**DRAFT REPORT
ROUND 7 DAM ASSESSMENT
CONSUMERS ENERGY COMPANY - D.E. KARN PLANT
1 & 2 SOLID WASTE DISPOSAL AREA
ESSEXVILLE, MICHIGAN**

January 12, 2011

Re: Round 7 Dam Assessment - Draft Report
EPA Contract No. EP10W001313
Consumers Energy Company D.E. Karn Plant
DE Karn 1 & 2 Solid Waste Disposal Area
Essexville, Michigan

**OVERALL KARN DISPOSAL AREA PLAN,
OBSERVATIONS AND PHOTOLOG**

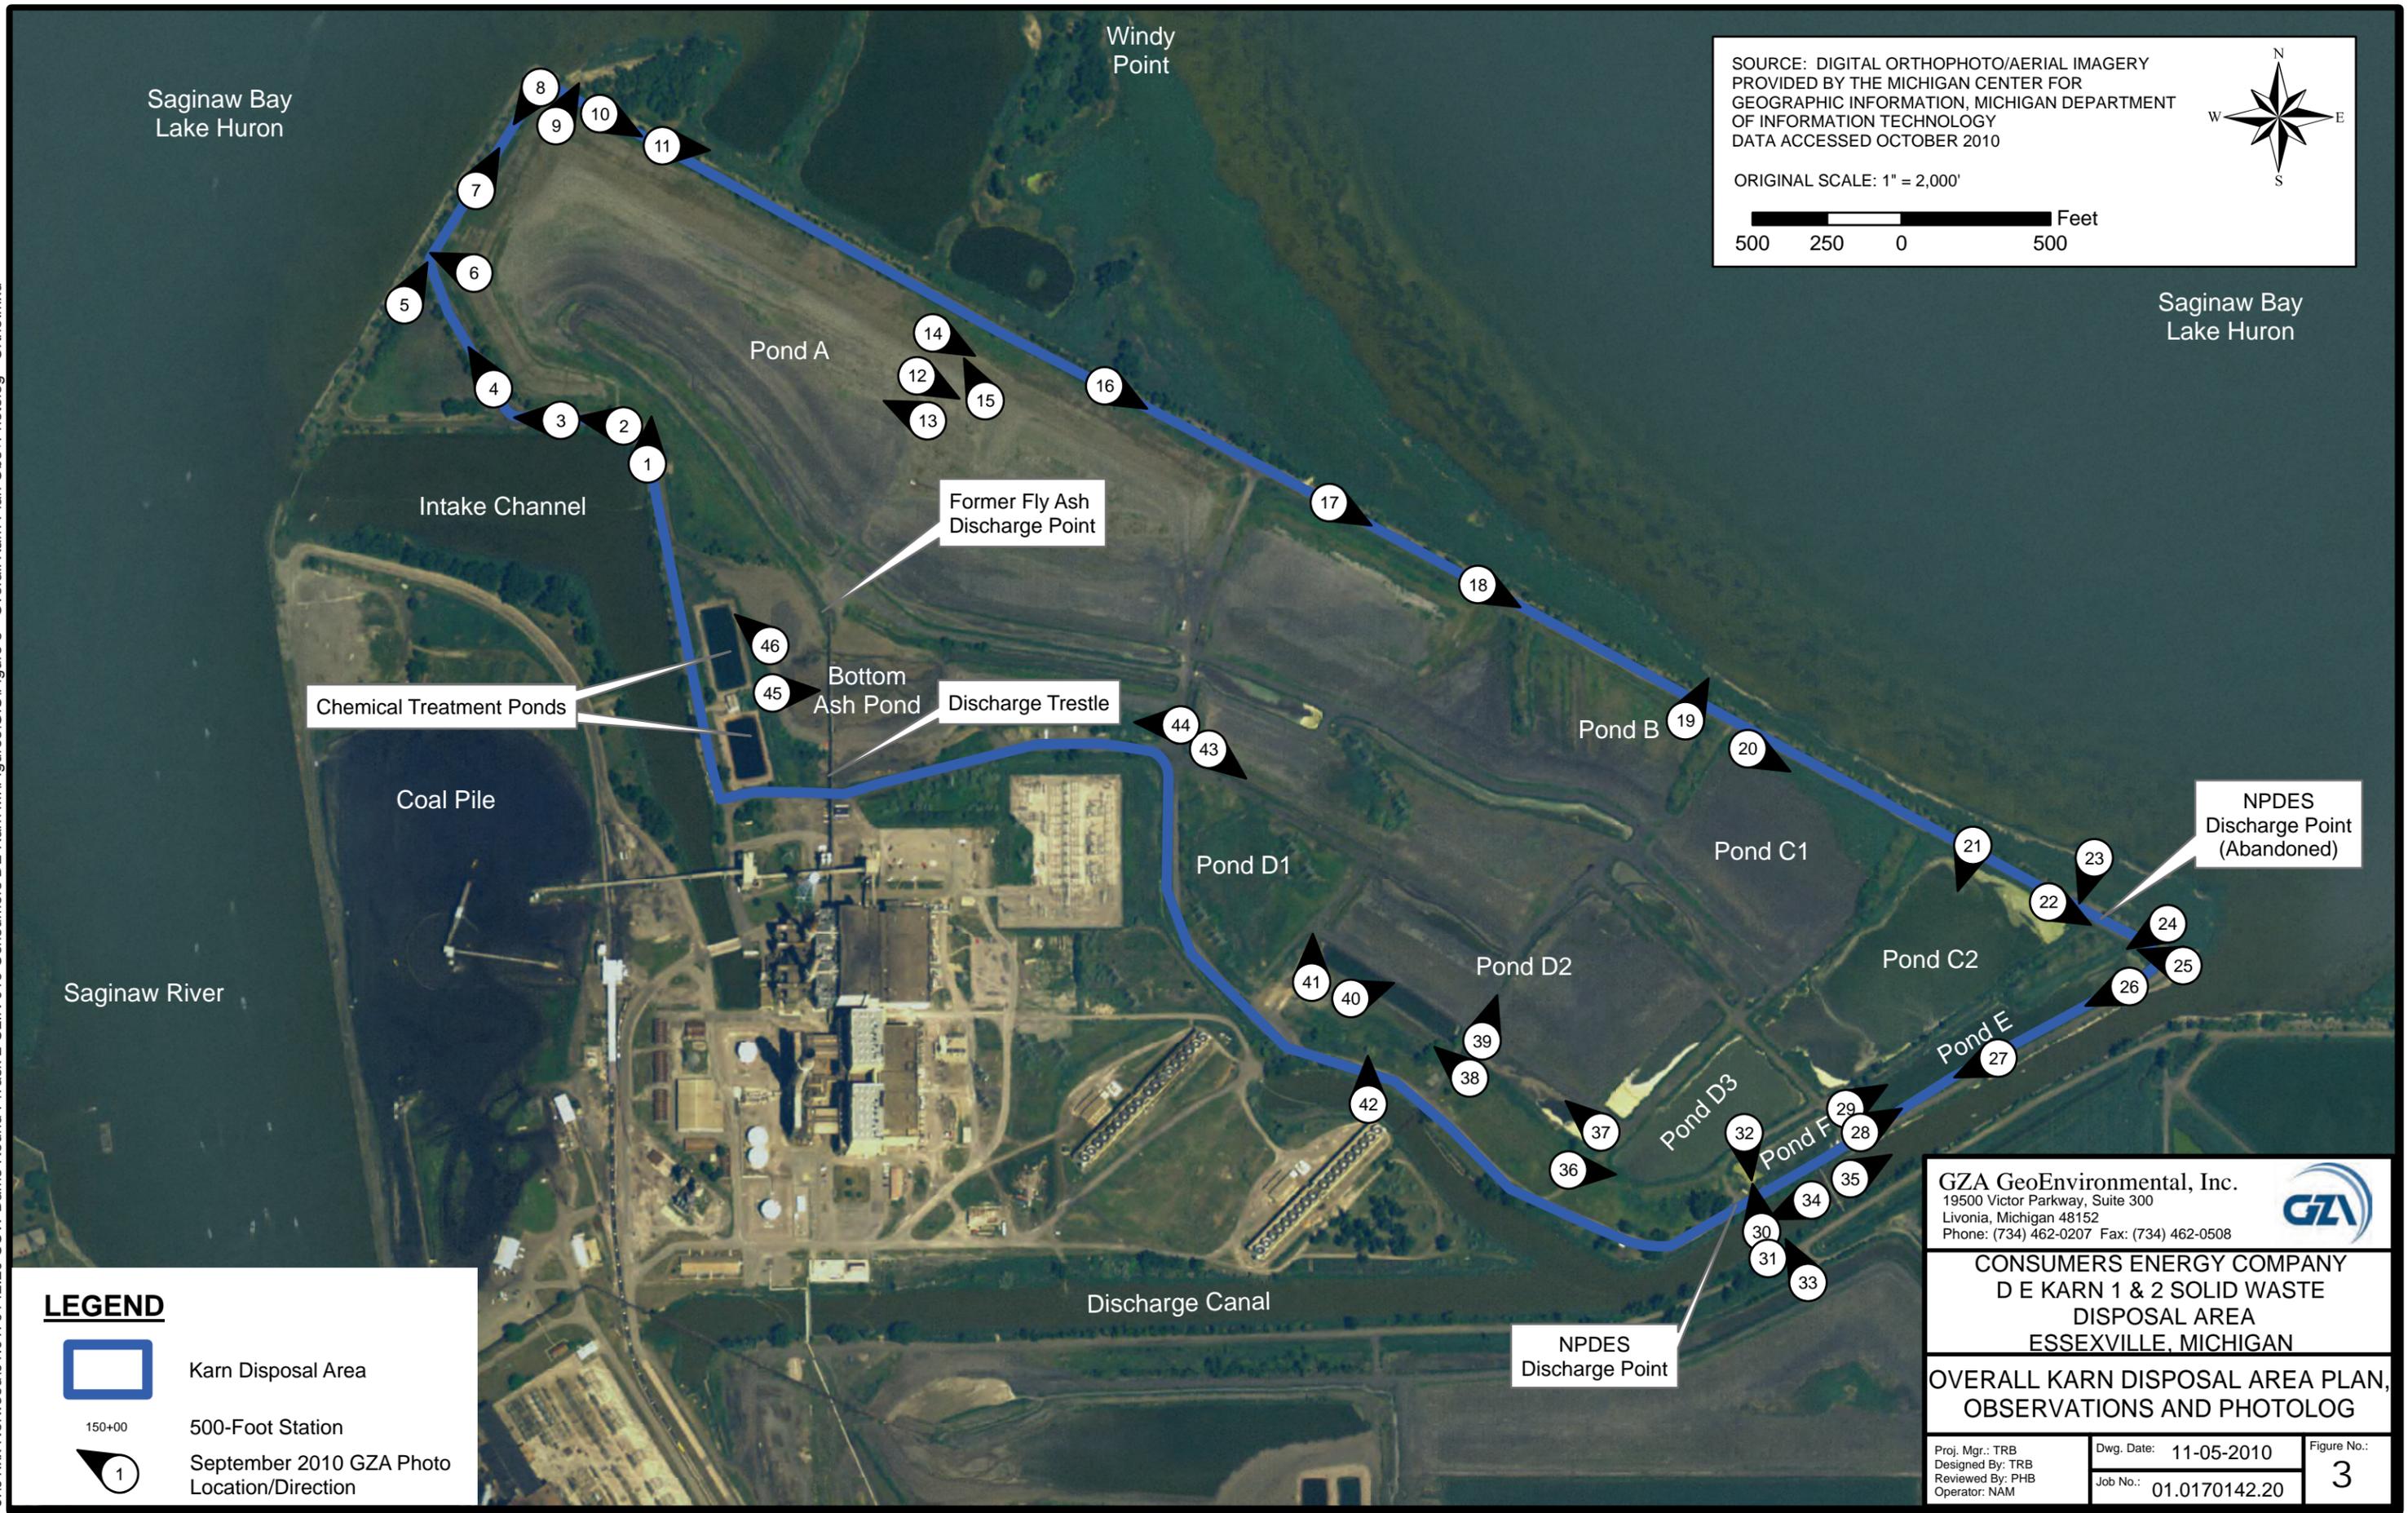
The condition of an abandoned outfall structure (Photo 25) (refer to **Figure 3** for its location) could not be determined due to presence of dense vegetation. CEC personnel indicated that the discharge piping had been removed and that the outfall was probably backfilled with concrete.

1. Remove the former NPDES discharge structure, including excavating and removing the former pipes, and replace with compacted fill.
